DESIGN AND CONSTRUCTION MANUAL DESIGN MODIFICATION REQUEST

PROJECT NAME: LSR7 Middle School #4 – Bailey Road

PERMIT NUMBER: PL2020134

Re: LSR7 Middle School #4 Stream Buffer Variance - PL2020209
Stream Assessment Design Memorandum

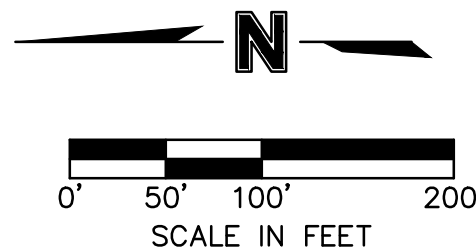
5605.3 Stream Preservation and Buffer Zones – we are requesting a waiver/modification to this section to encroach on the prescribed stream buffer widths in specific areas as identified on the attached drawings. Our encroachment is needed due to the nature of the site being narrow in the east/west direction and meeting the program requirements for all of the components needed on site by the school district. The grade of the site falls from west to east towards the existing streamway. Again, with the narrow site it is difficult grade out the site for buildings, fields, and parking and not have the slope embankment encroach into the buffer.

According to the requirements of Section 5605.3, a total of 2.08 acres should be dedicated to the stream setback. To accommodate the improvements noted above a total of 0.74 acres will have to be removed from the 1.34 acres. Per Exhibit 1 in this submittal. An additional 0.76 acres will be added to the easement. This results in 2.10 acres of permanent stream setback dedication.
